**URGENT: FIELD SAFETY NOTICE**

**Level 1® H-2 Pressure Chambers**

8<sup>th</sup> August 2022

**Figure 2: Wide Hinge Width 54mm  
(Affected Chambers)**

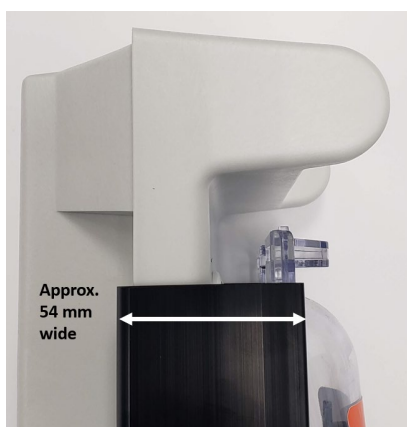
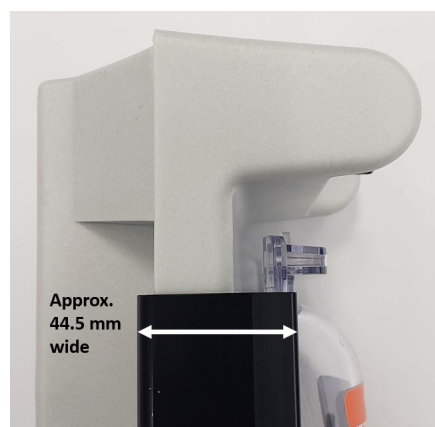
Smiths Medical implemented a design change to widen the hinge assembly on the Level 1 H-2 Pressure Chambers used with the Level 1 Fast Flow Fluid Warmers (Models H-1025 or H-1200) or added to the H-1000 model. Smiths Medical has become aware that Level 1 H-2 Pressure Chambers with the wider hinge assembly can potentially impact the amount of pressure exerted onto the IV fluid bag while contained within the pressure chamber. This may result in decreased flow rate, stopped flow or residual fluid left within the IV bag.

Pressure chambers with the wide hinge assembly are more susceptible this issue in the following scenarios:

- 1) kinked tubing on the disposable administration sets.
- 2) use of the lowest flow rate disposables (DI-50, D-70 or DI-70) when delivering viscous fluids such as chilled blood from 300 mL or smaller IV bags.

- ii. If you have a Level 1 H-2 Pressure Chamber with a serial number not included within the affected serial number range, then you will need to verify if the pressure chamber has been modified using a Level 1 H-2 Pressure Chamber Door and Latch Replacement Kit or the H-2 Plus Latch Assembly/Door Assembly. You can confirm this by measuring the width of the pressure chamber door/hinge and latch as shown in Figures 2-3 below.

- iii. If you have a Level 1® Pressure Chamber Door and Latch Replacement Kit, Latch Assembly H-2 Plus or Door Assembly H-2 Plus you will need to verify if these are the wide or narrow hinge assemblies. You can confirm this by measuring the width of the hinge assembly as shown in Figures 2-3 below.

2. If the device has the narrower hinge assembly as in Figure 3, then it is not affected, and you can continue to use the device per the instructions in 3b and 3c below.

3. If the device has the wider hinge assembly as shown in Figure 2, then it is affected, and the hinge should be replaced. Smiths Medical will contact you when the replacement kit is available through the email id [PressureChamberFieldCorrection@icumed.com](mailto:PressureChamberFieldCorrection@icumed.com). Until the replacement kit is available, please take the steps described below:

In the interest of deploying the correction to this issue in a timely manner, Smiths Medical will be providing a replacement kit and associated instructions to customers so they can modify any affected Level 1 H-2 Pressure Chambers with a narrower hinge assembly. Smiths Medical will contact customers when replacement kits are available. Please note that changing of the hinge by hospital personnel will not affect the warranty.
